Titel / Titre / Title Comments to the PMP Setup & Calibration Procedure		Bericht / Rapport / Report 2007-230-629	
Verfasser / Auteur(s) / Author(s) Jürg Schlatter		Datum / Date 28. June 2007	
Empfänger / Destinataires / Addressees Federal Office for the Environment FOEF Federal Roads Office FEDRO PMP-GRPE METAS: Sz, FI, Ri, Anha		Beilage(n) / Annexe(s) / Enclosure(s) none	
Zusammenfassung / Résumé / Summary <p>An experimental setup with associated calibration procedures for the measurement of particle number concentration of diesel engine exhaust gases was proposed from PMP (Particle Measurement Project) to UNECE, the World Forum for Harmonization of Vehicle Regulations (WP 29) to be included as appendix 4a in ECE-R 83. The Automotive industry (OICA) provided experimental data, revealing, that the proposed PMP setup and calibration procedures result in a poorer accuracy than the established gravimetric method. Therefore UNECE has postponed the inclusion of appendix 4 a in the ECE-R 83.</p> <p>On request by the involved bodies (FOEF, FEDRO and PMP) METAS analysed the proposed experimental setup with associated calibration procedure and detected several points for potential accuracy

Figure 1 Schematic diagram of particle number emissions measurement system.

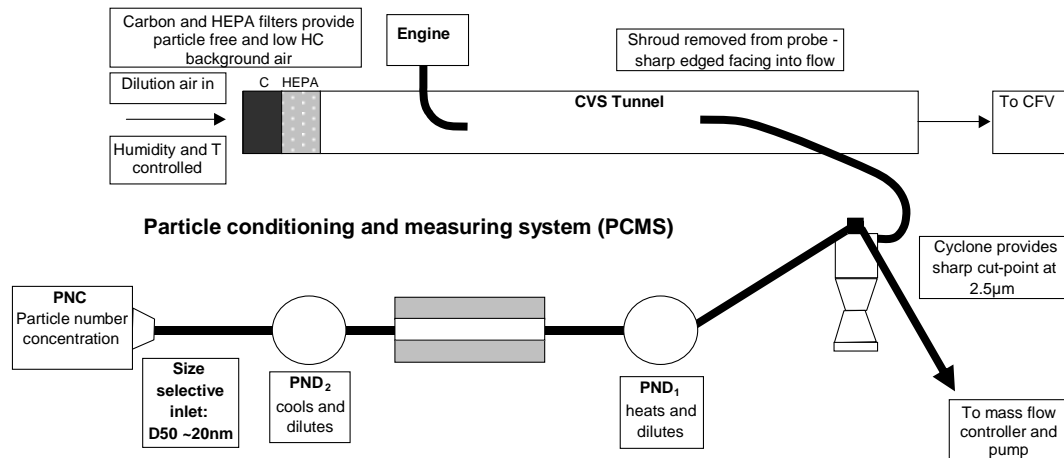
The proposed procedures for the calibration of the measuring system for exhaust describe the "calibration" of single components as PND, ET or PNC. The term calibration is not correct for all the proposed procedures. The procedures are a mixture of calibration, testing and verification.

- Cyclone: Up to now no examination of the influence of the cyclone is provided
- PND: Calibration of the dilution factors with gas is not equivalent to dilution factors with particles!

- PND: Control of the penetration efficiency is only used to define specifications. Penetration is evaluated for particle diameters 30 nm, 50 nm and 100 nm

- PNC: Control of the linearity, Calibration of the flows, Calibration with a reference PNC (more significant than linearity check and shall replace it)

- Response Time: Up to now no examination of the behaviour with fast concentration changes is provided. But the response behaviour can be important, if short events with high concentrations contribute a large fraction of particles.

- Each component of the Particle Conditioning and Measuring System (PCMS) contributes a portion of uncertainty. Therefore accuracy can be gained by simplifying the measuring system. The most obvious simplification is to remove one PND.

The "component calibration" characterise the system step by step. This characterisation is not sufficient to guarantee reliable results, because slight modifications for the final setup and interaction of the components can falsify the results. Example: Changing the pressure in the tubes of PND change the dilution flows, dilution ratio, and particle loss and the aerosol flow in the PNC.

Figure 2 Comparison of the two concepts for the indication of particle dilution (principle): Arrows show the maximal deviation of effective to the reference value (circles). Using f_r instead of PE=100% leads to smaller deviations

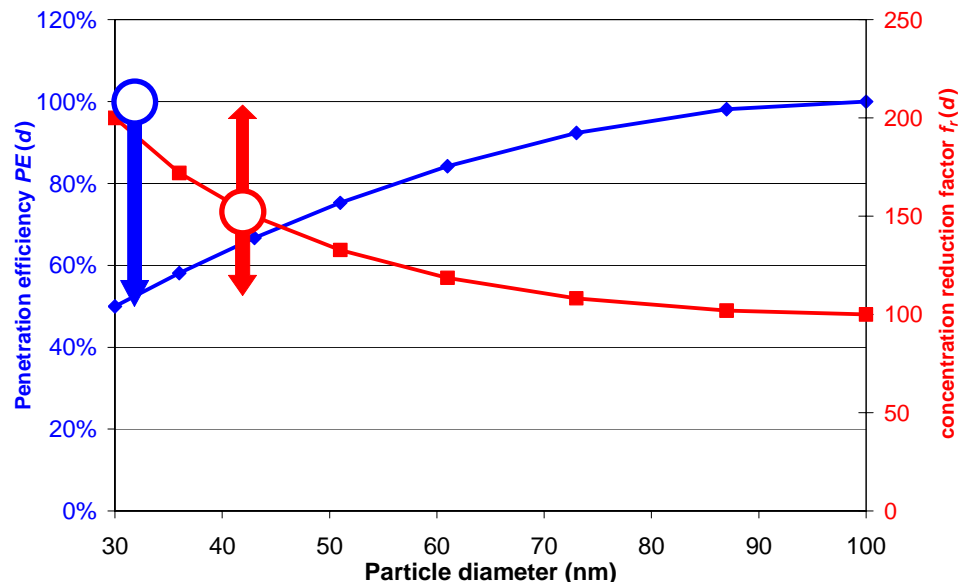
The proposed calibration procedure demands in a first step the calibration of the diluters with trace gas in order to give a nominal dilution factor. In a second step it defines minimal penetration efficiencies. This procedure in two steps creates bias and uncertainties that are not necessary.

Particle diluters shall be calibrated directly with particles, because particles do not behave like gases. The size dependent losses are too important. The expression "dilution factor" (PND-DF) is misleading; we propose to define a "particle concentration reduction factor".

The term "dilution factor" implies the image of mixing two flows, where the merged volume flow and the merged mass flow correspond to the sum of the initial flows (conservation of mass). Starting with PND-DF and defining minimal penetration efficiencies (PE) always leads to systematically too small particle concentrations, because losses are not compensated. Therefore the concentration of 100 nm particles (diluted with a PE of 80 %) underrates to 20 %, with 30 nm particles even up to 50 %. There is no particle size with a correct concentration measurement. This is a large contribution to the uncertainty.

The term "particle concentration reduction factor" $f_r(d)$ just implies the over-all quotient between the inlet concentration N_{in} and the outlet concentration N_{out} for a given particle diameter d : $f_r(d) = N_{in} / N_{out}$. The reason or the physics for the reduction of the particle concentration is not important, as long as it is reproducible and identical for all particles of the given size. This concept should be applied for the over-all system (from CVS Tunnel to PNC). Working with f_r , the deviations are symmetric. While the concentration of 100 nm will be overrated, the concentration of 30 nm will be underrated. The concentration measurement of a size in between will correct. The use of this reference value will lead the smaller uncertainties (see Figure 2).

In any case (both concepts) in order to get reliable measurements the size dependence of the losses must be reduced. This is the legitimate objection of automotive industry (OICA). The "particle concentration reduction factor" shall not vary more than 20 % in the range from 30 nm to 100 nm, this means $f_r(30 \text{ nm}) / f_r(100 \text{ nm}) > 0.8$. Probably not all diluter systems can fulfil such tough requirements.
